APPLICATION NO:
F/2000/0966

PROPOSAL:
Proposed front and rear extensions to dwelling plus loft conversion.

RE: PROPOSED EXTENSIONS TO 47 BEECH LANE, EARLEY

PROPOSED CONVERSION OF EXISTING BUNGALOW WITH ROOMS IN ROOF & REAR EXTENSION AT 47, BEECH LANE, EARLEY FOR MS. S. PERCIVAL

DWG No.: 5K/606.
SCALE: 1:100
DRAWN: R.F.H
DATE: FEB 2000

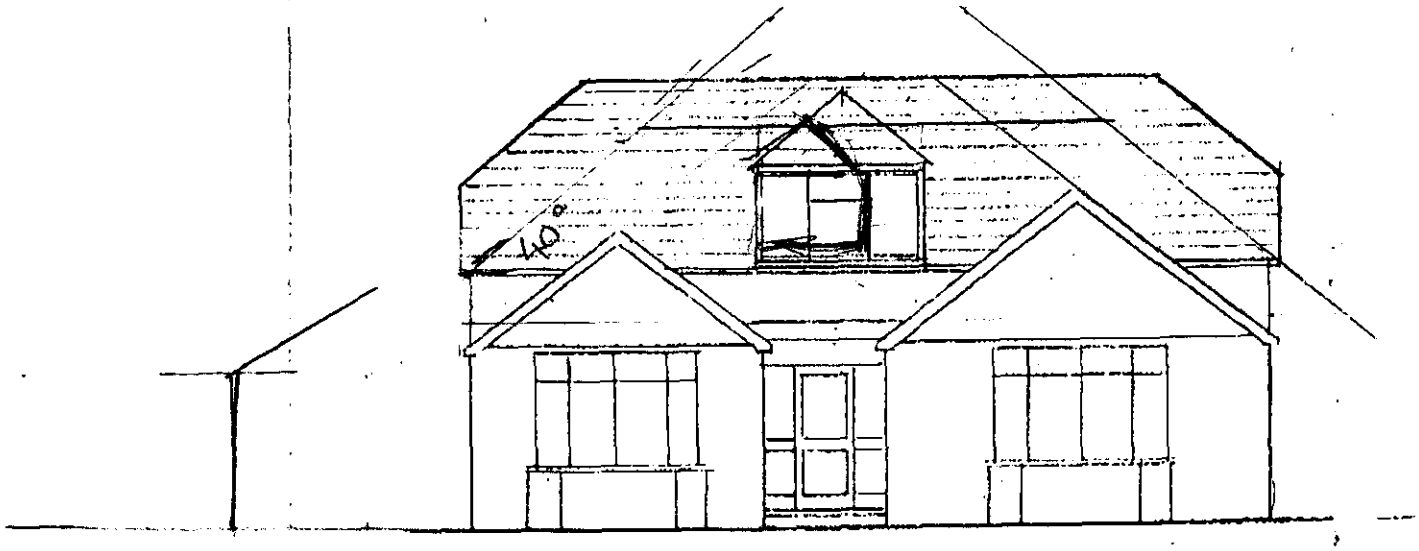
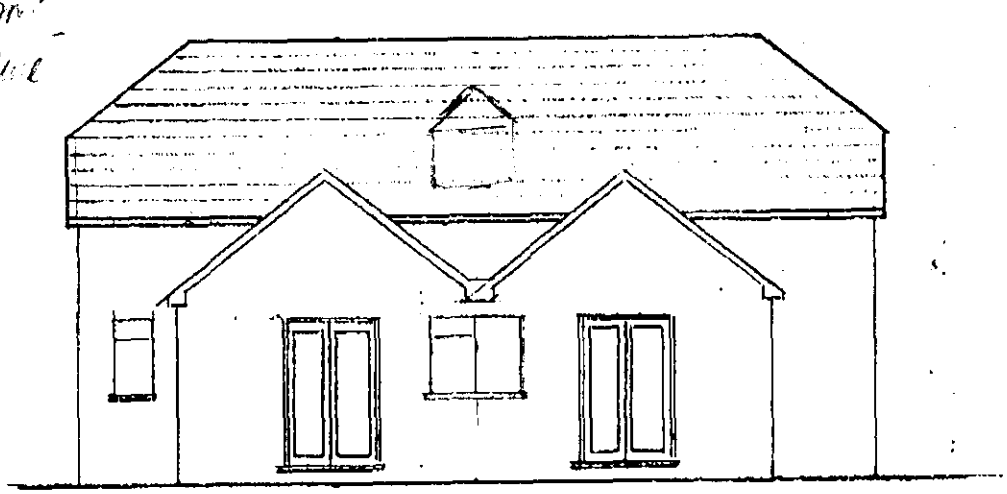
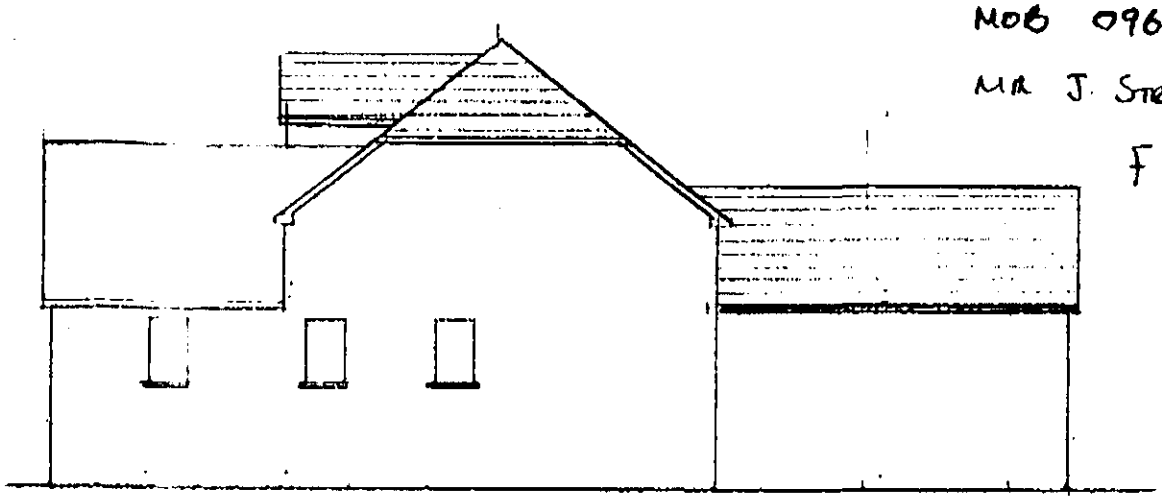
(1) [illegible] (40° pitch) from proposed gutter line

(2) dormers to be reduced to 2/3rd proposed width, [illegible] 500mm from vertical wall + hipped roof (can have one at rear as well)

(3) front + rear single storey [illegible] maybe OK but wish to see plans

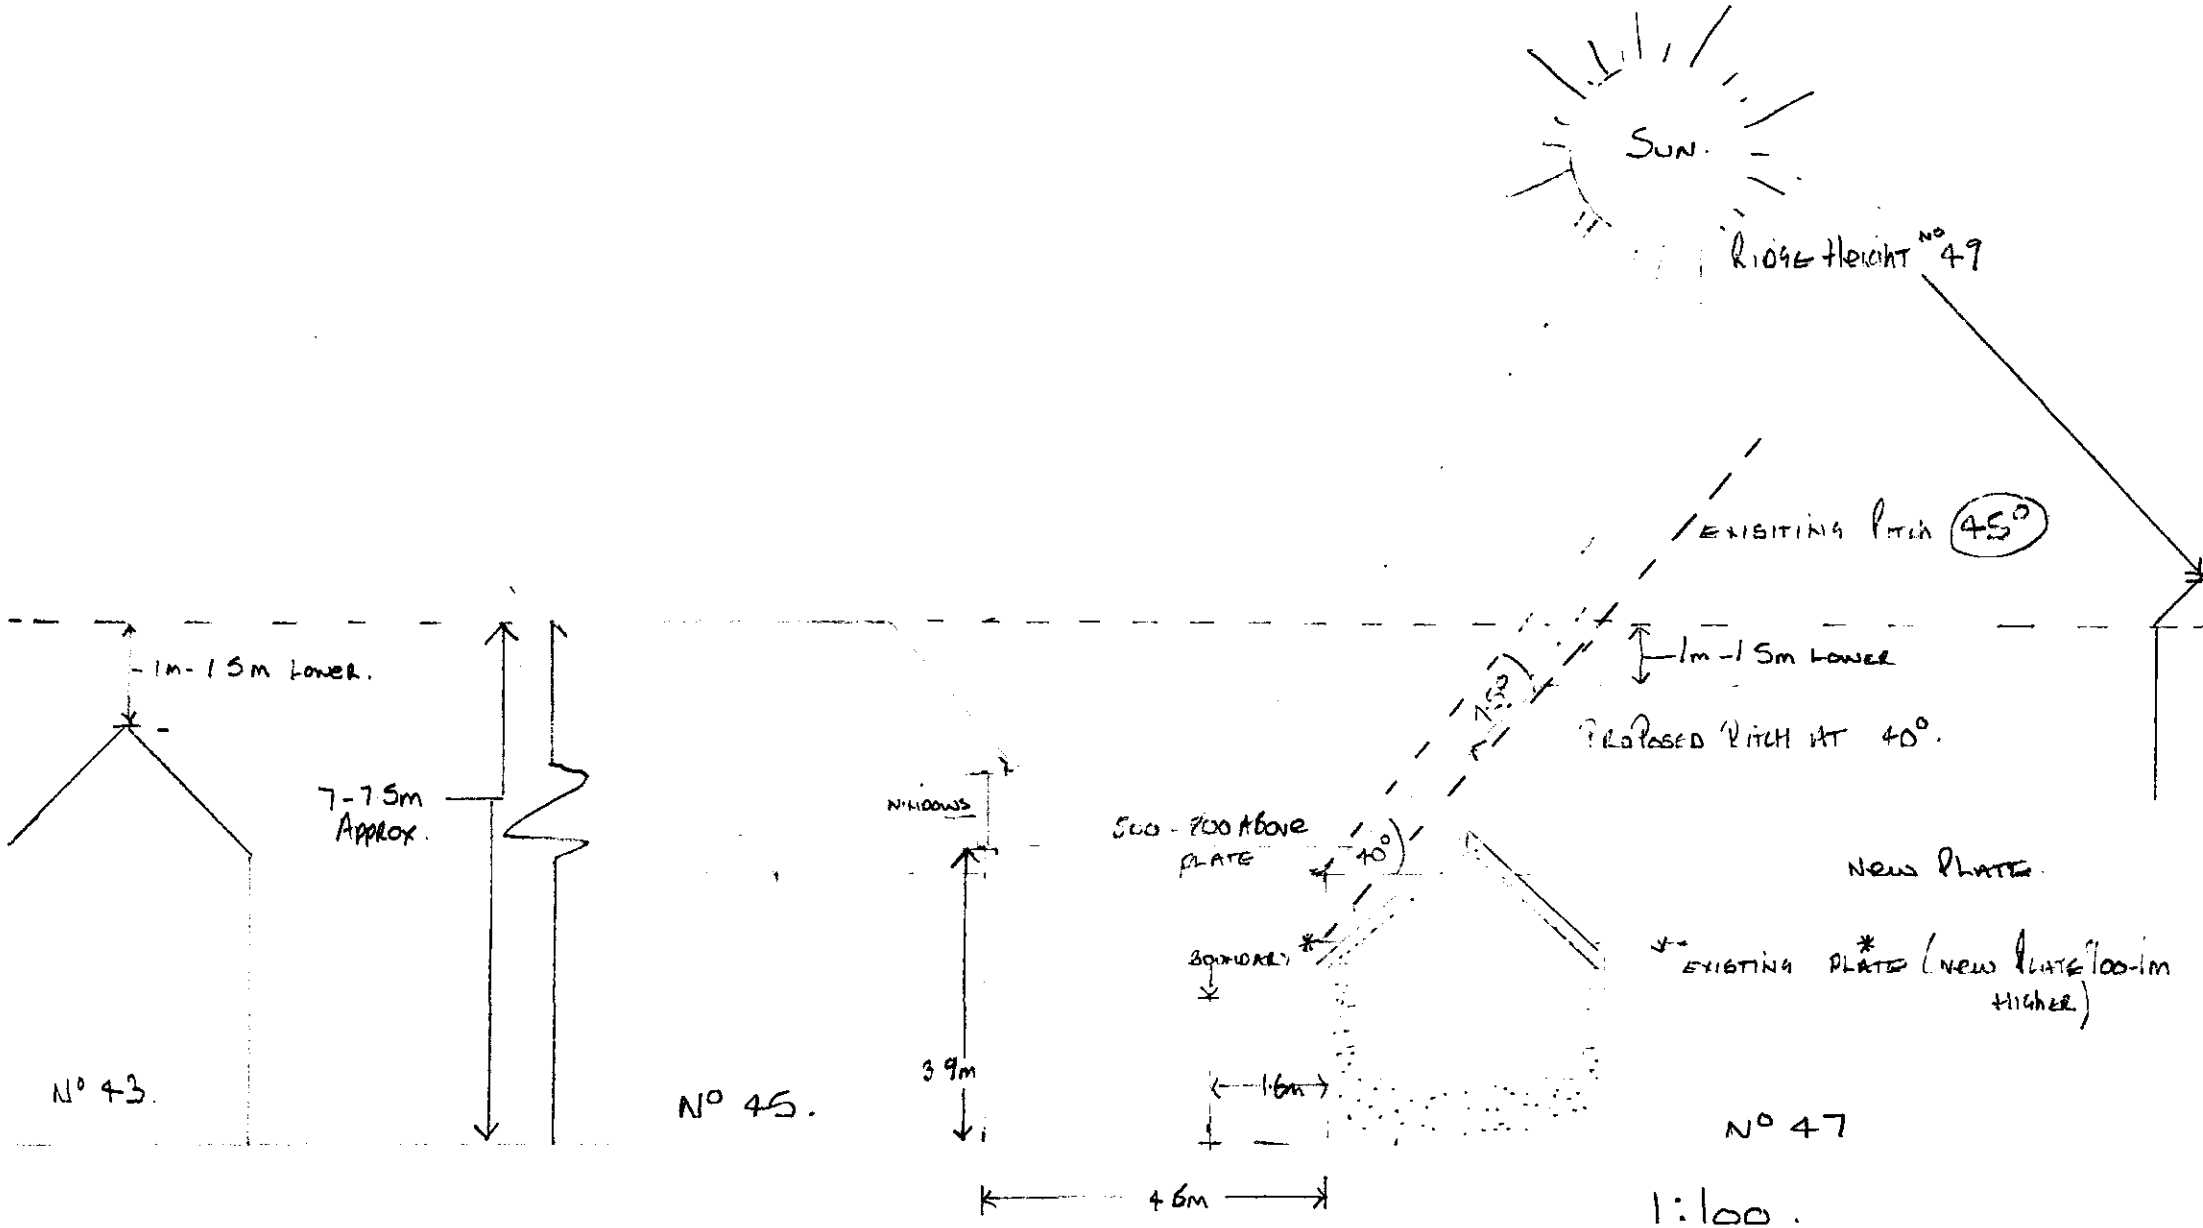
SUN.
RIDGE HEIGHT Nº 49
EXISTING PITCH (45°)
1m-1.5m LOWER
PROPOSED PITCH AT 40°.
1m-1.5m LOWER.
7-7.5m APPROX.
NEW PLATE.
EXISTING PLATE* (NEW PLATE 100-1m HIGHER)
Nº 43.
Nº 45.
Nº 47
3.9m
1.6m
4.6m
1:100.
